Eagle Ranch Association
Regular Meeting
Design Review Board

MINUTES OF A MEETING OF
THE DESIGN REVIEW BOARD OF
EAGLE RANCH ASSOCIATION

Design Review Memorandum

Project Number: 25-00-64
Owner Name: Jill and Collier Pennington
Architect: Brennen Fitzgerald – Scott Turnipseed AIA
Address: 1880 E Haystacker Dr
Legal: EAGLE RANCH FILING 25 Lot: 64
Preliminary DRB Meeting Date: April 18, 2024

1 EXTERIOR LIGHTING PLAN
 A1.3 SCALE: 1" PER 10'-0"

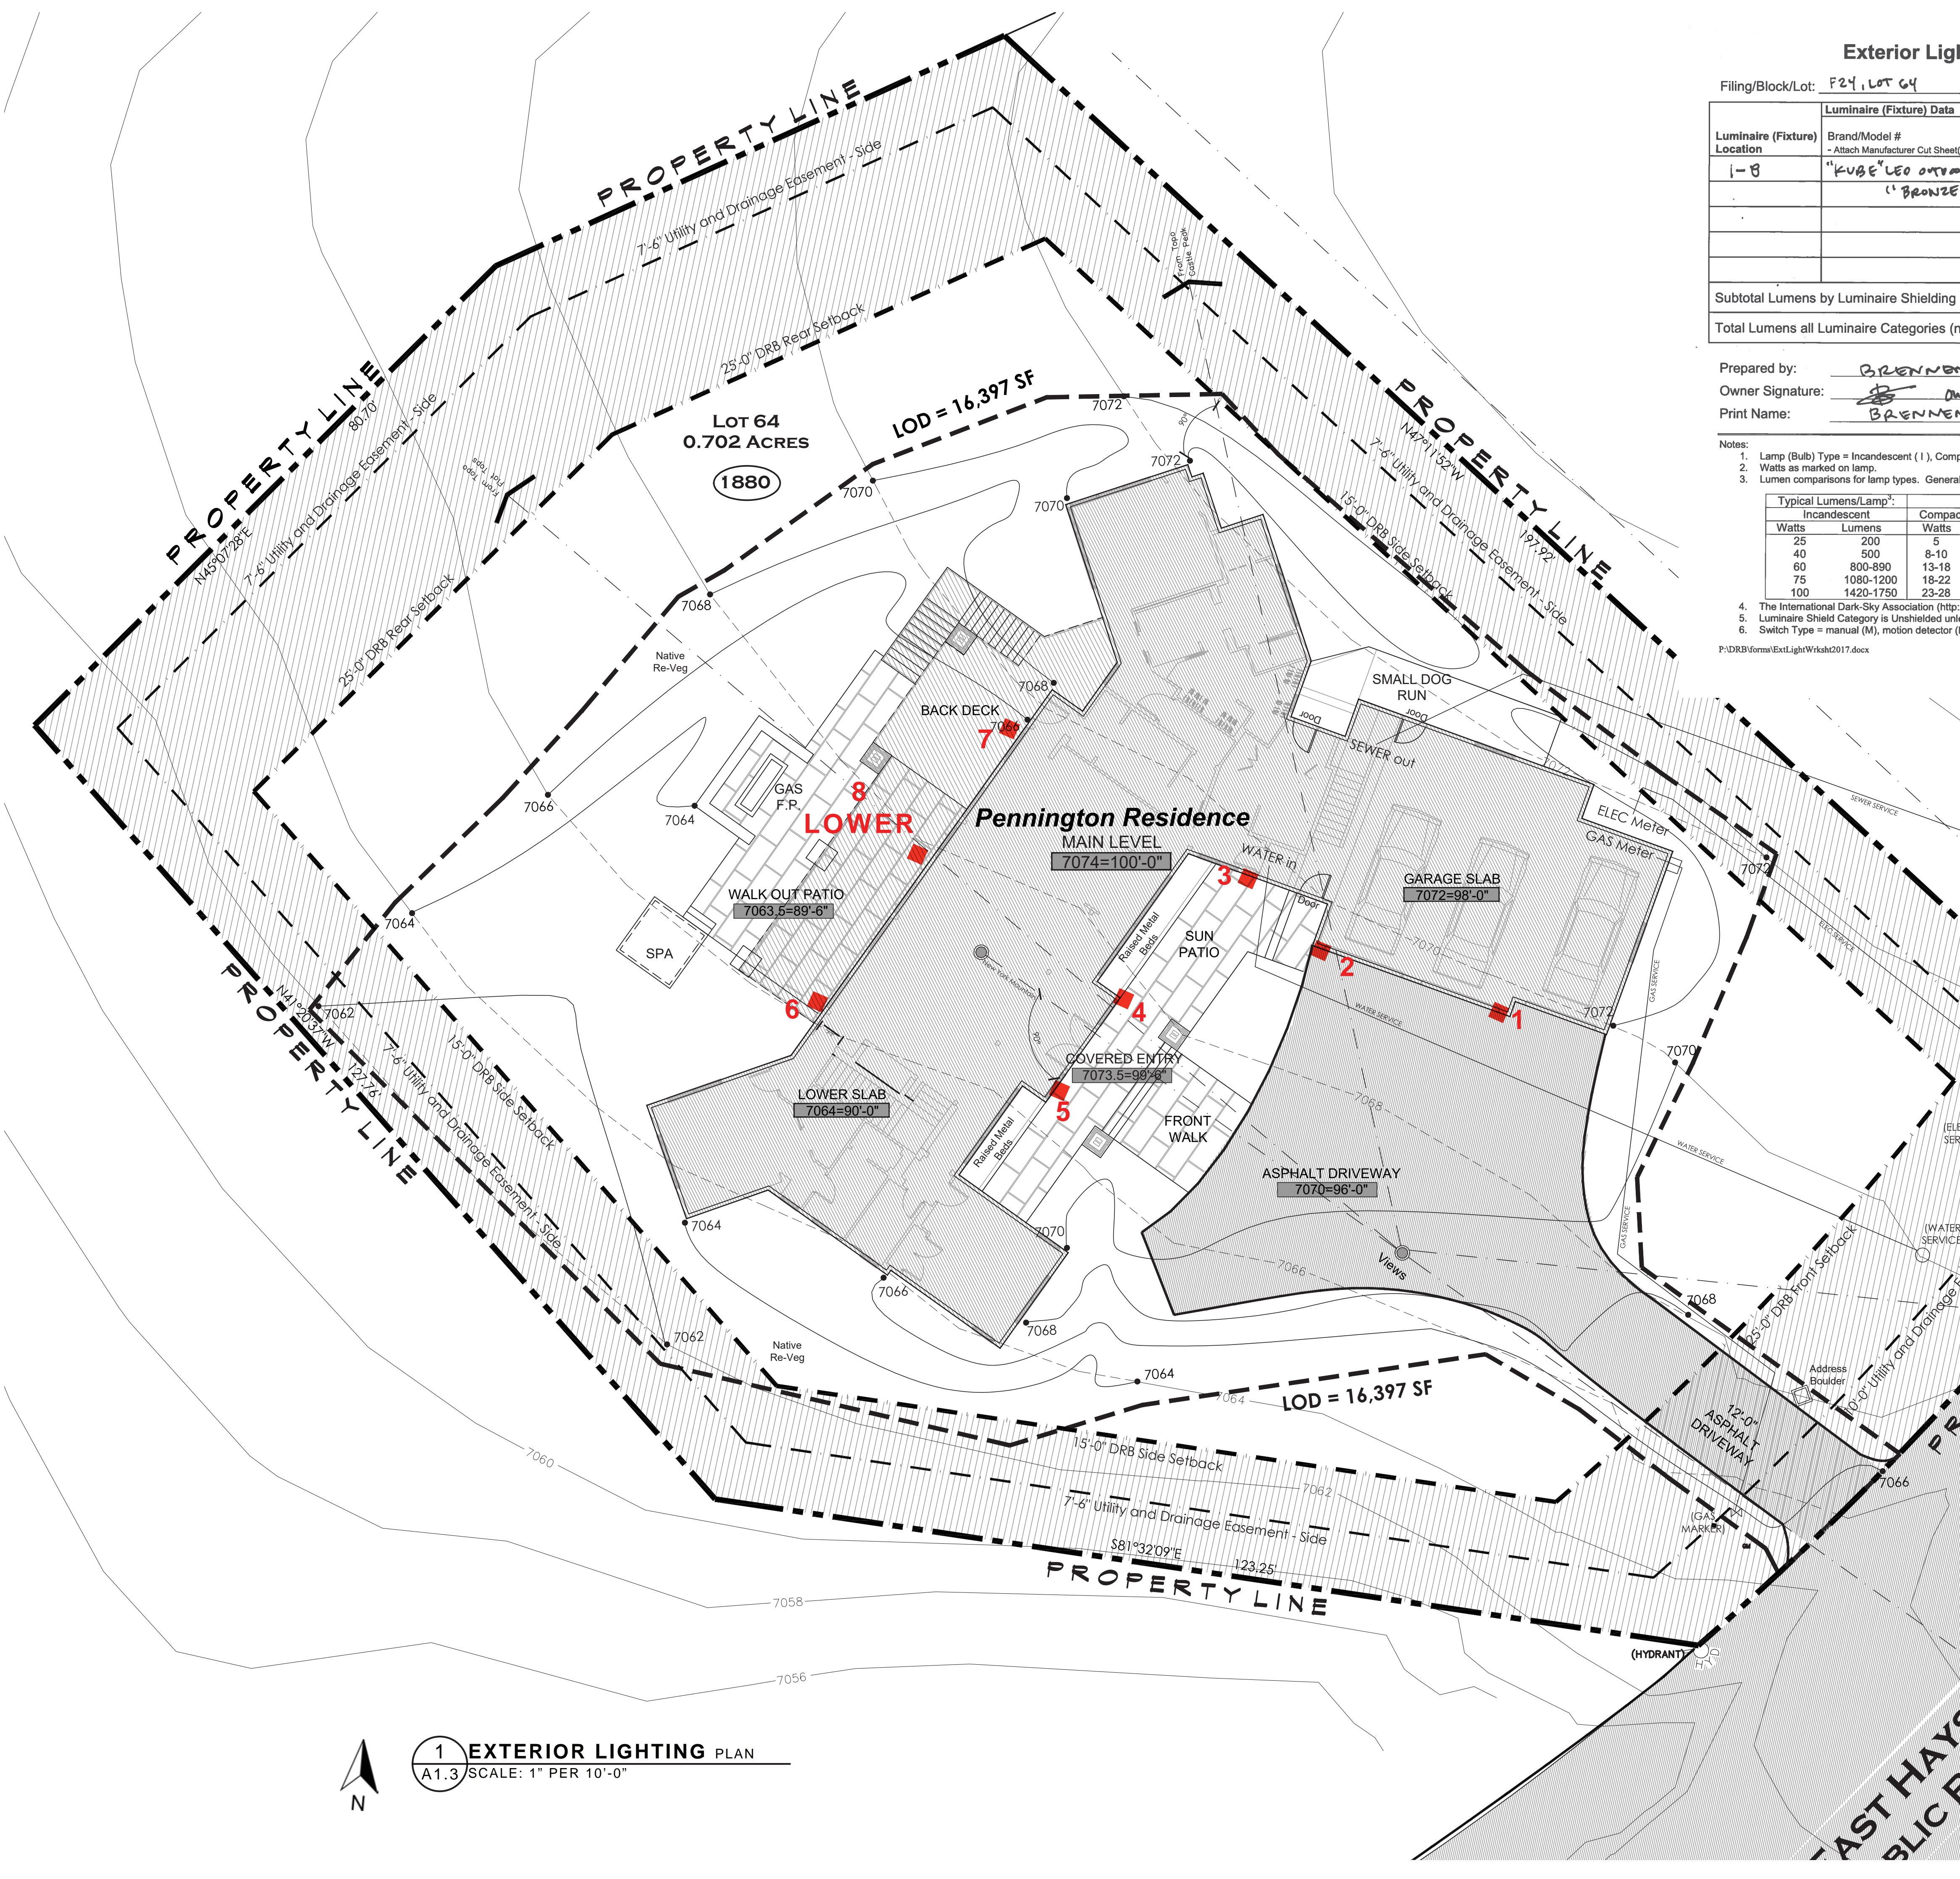
Include complete light fixture spec sheet that shows Lumens

1 ROOF LEVEL PLAN
A2.2 SCALE: 3/16" PER 1'-0"

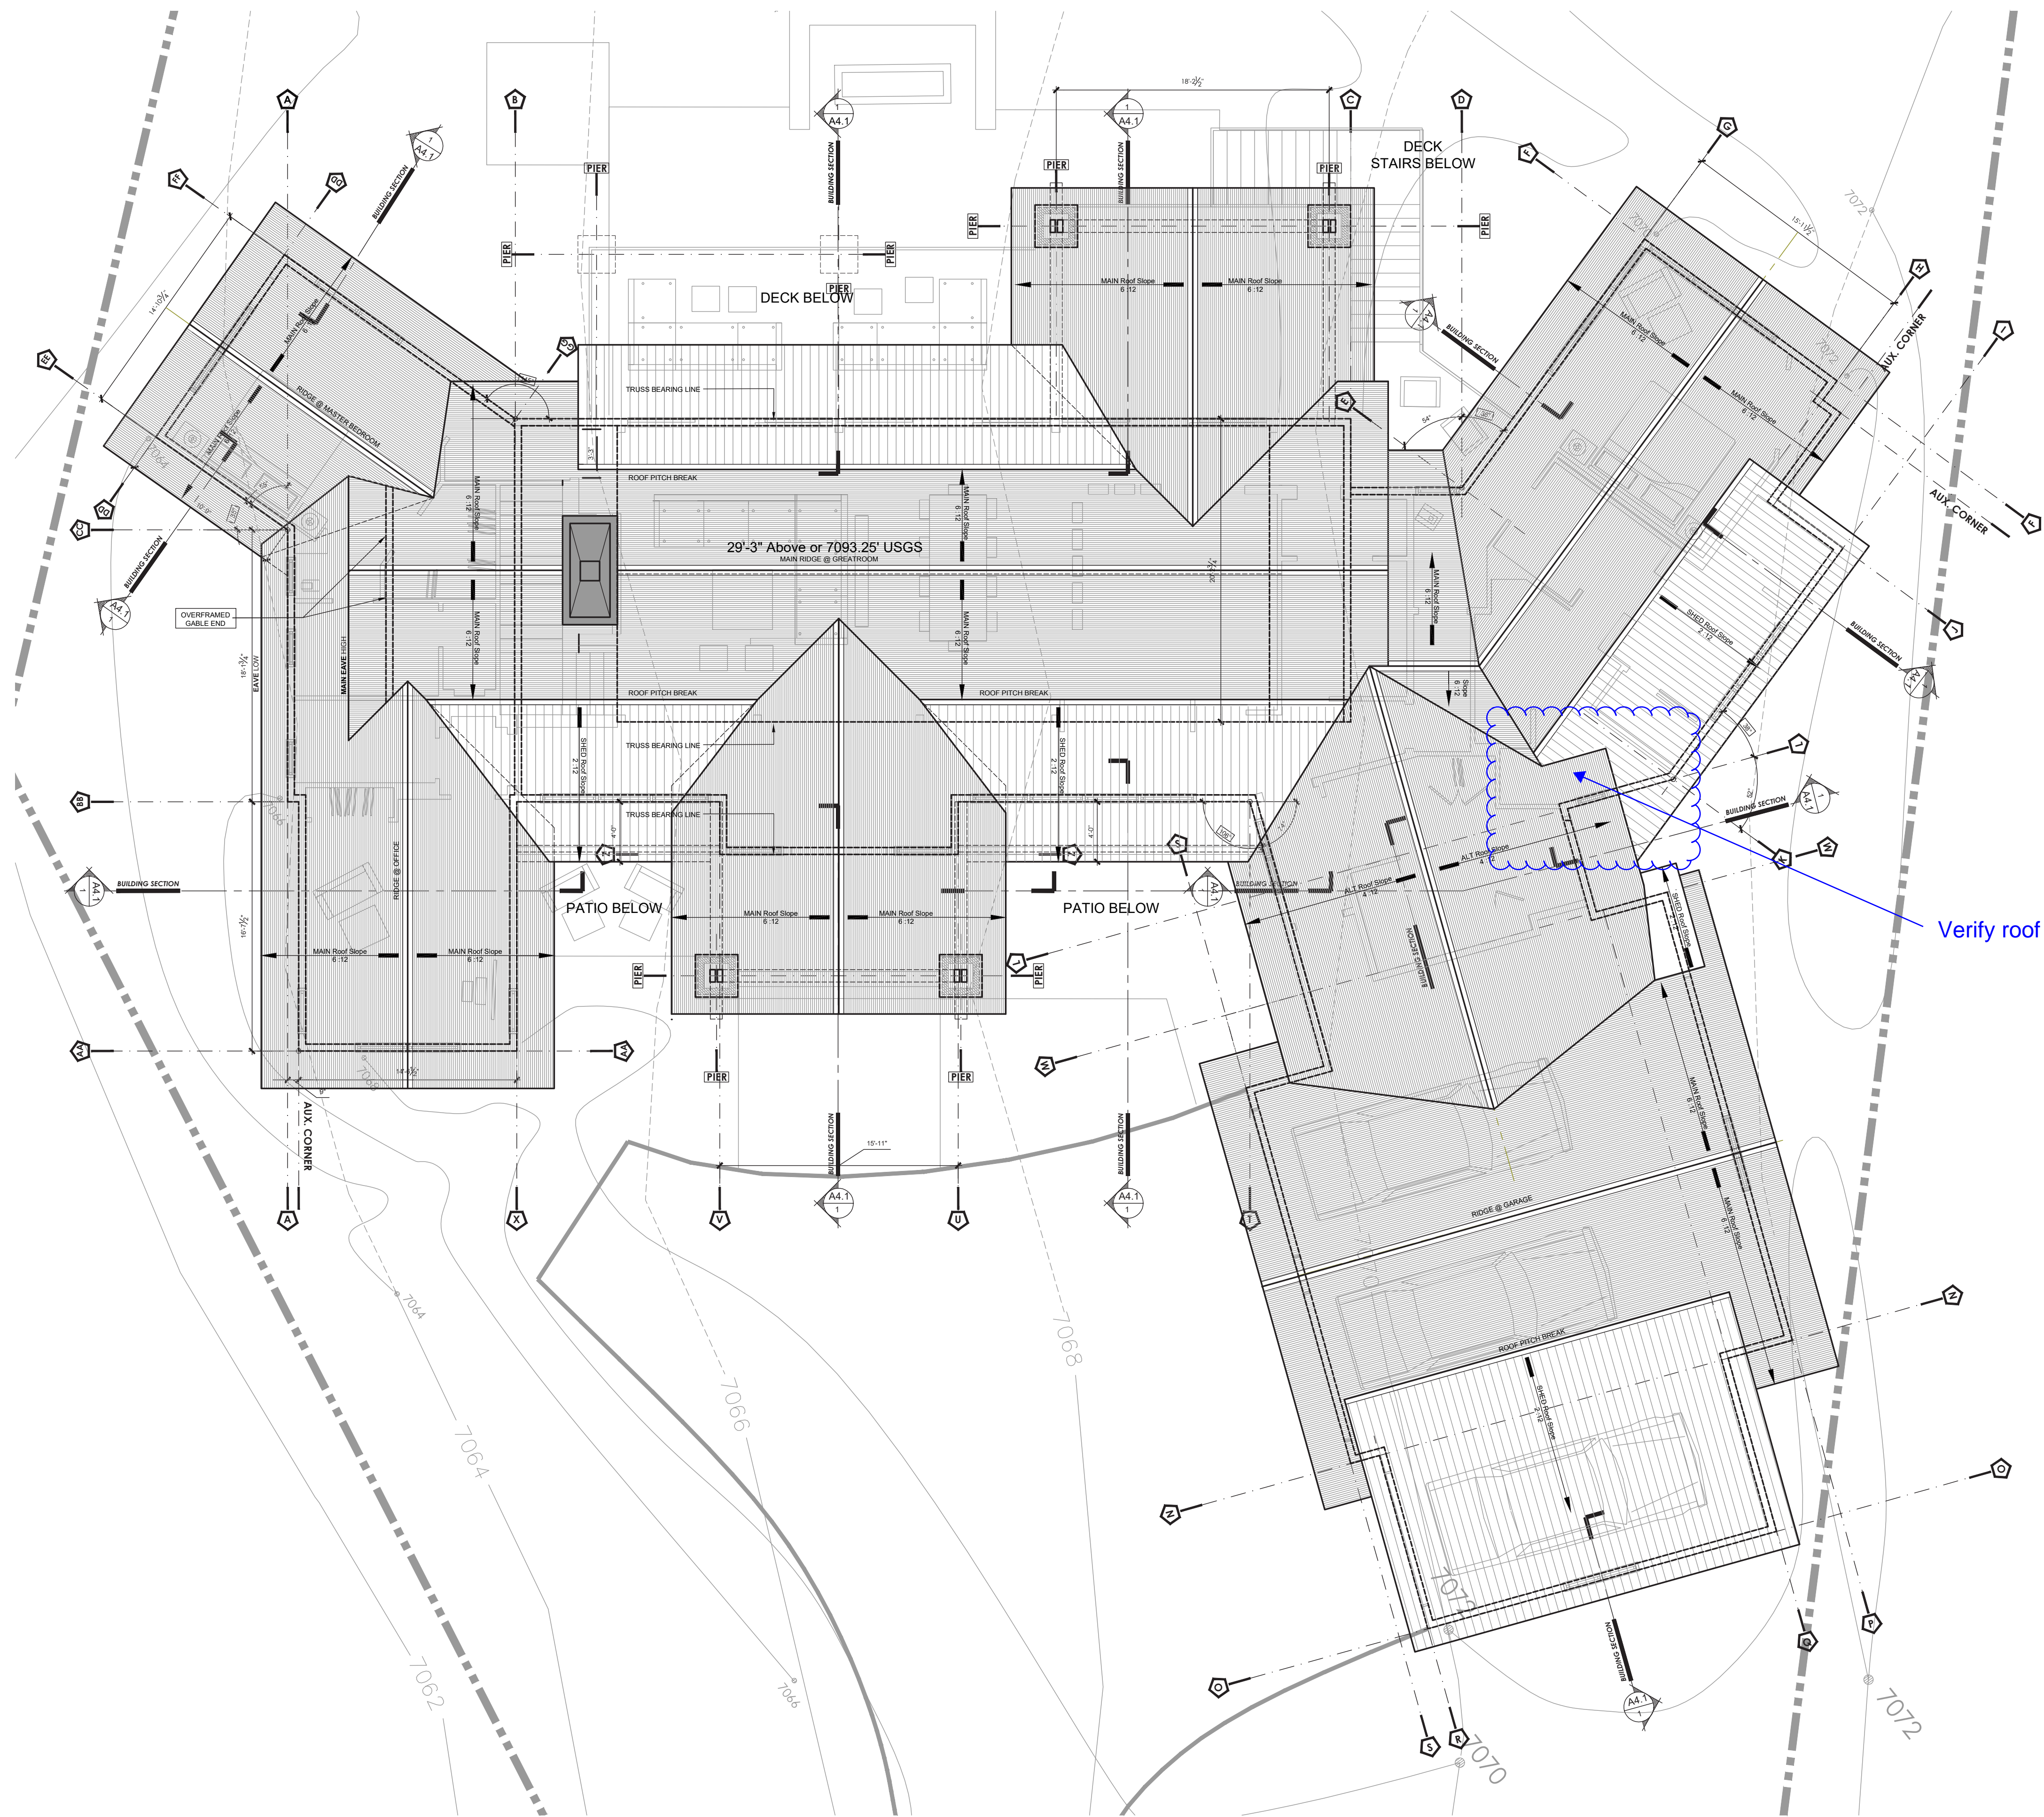
Verify roof plan (intersections) in this area.

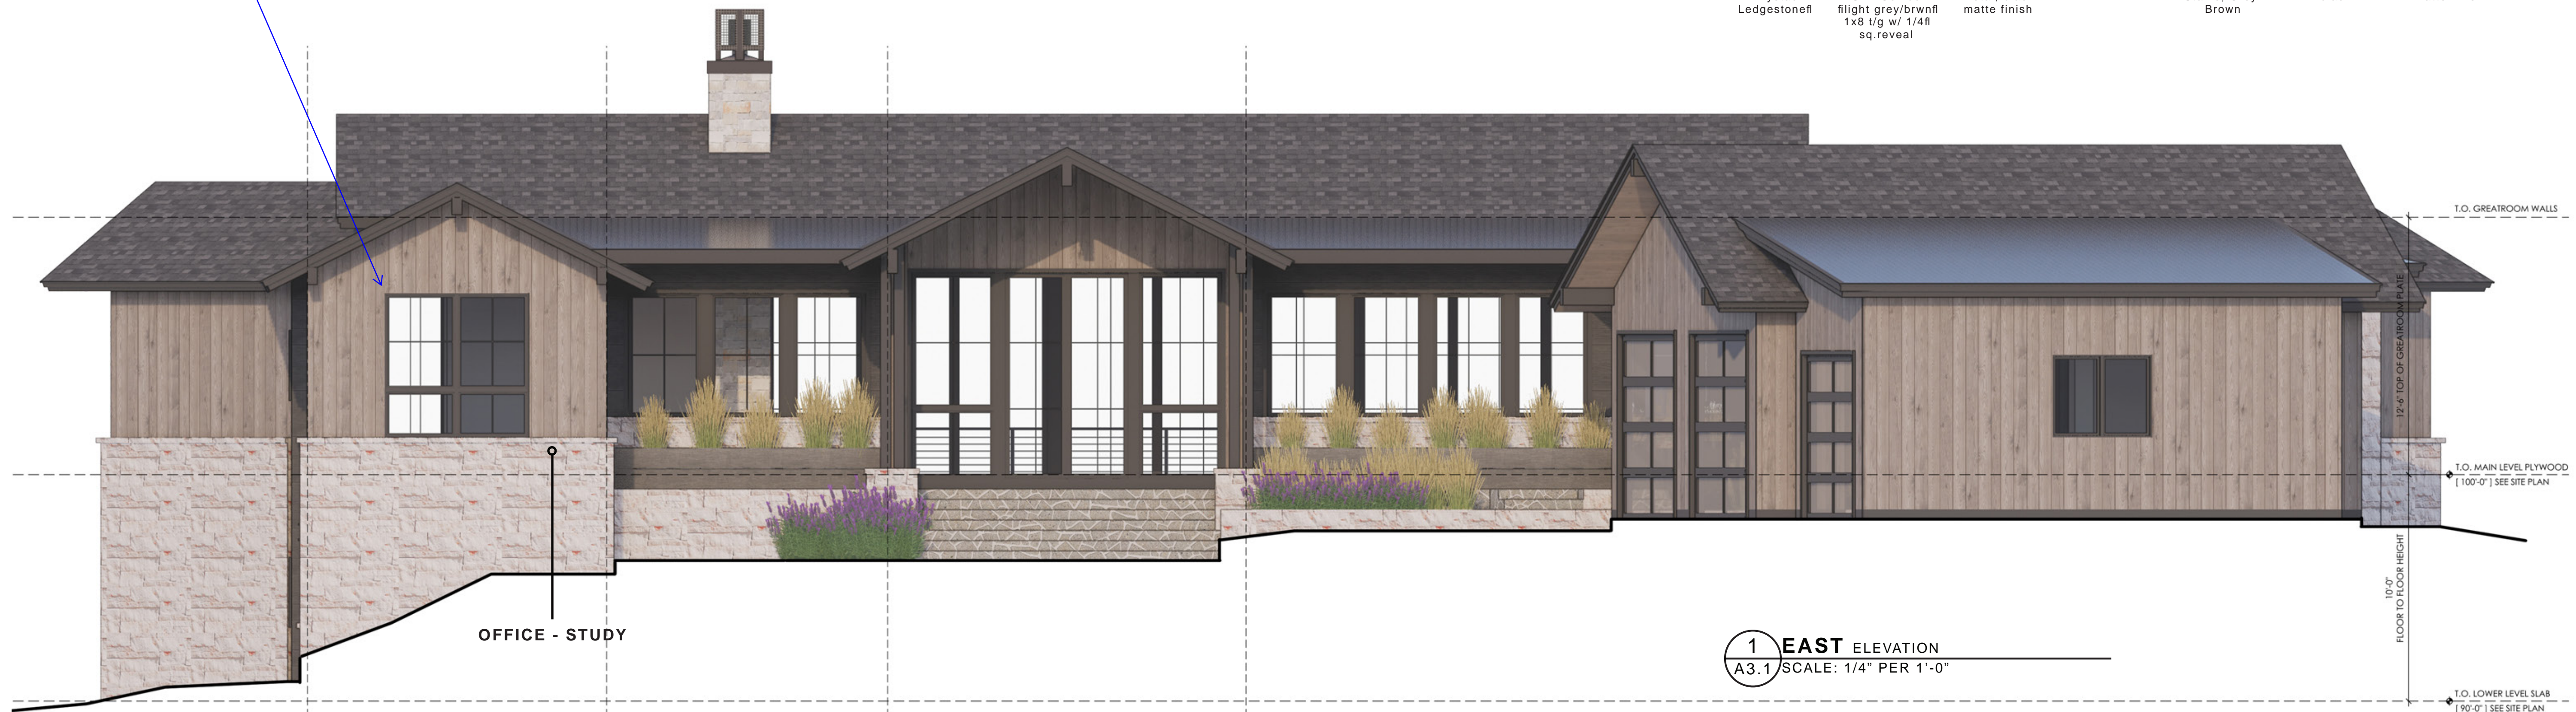
2.3.3.2 (5) Windows set in rustic barn wood siding or metal may be installed without window trim if approved by the DRB.
